Redesign of unit electro mechanical operation.

PLATE #2

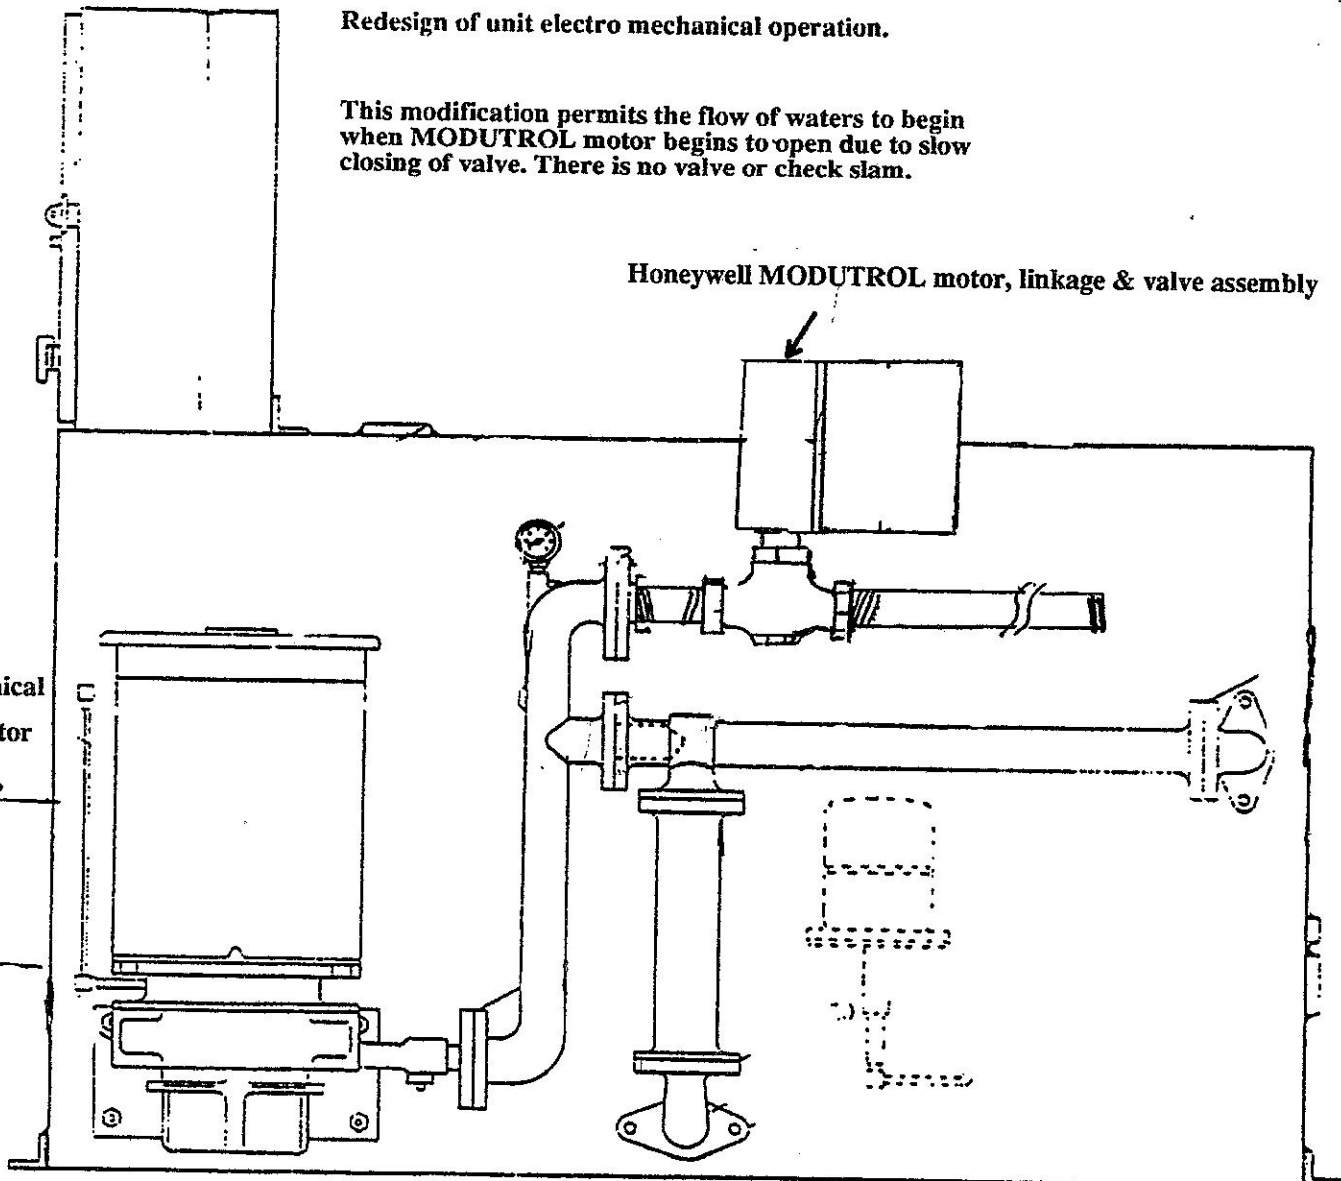
This modification permits the flow of waters to begin when MODUTROL motor begins to open due to slow closing of valve. There is no valve or check slam.
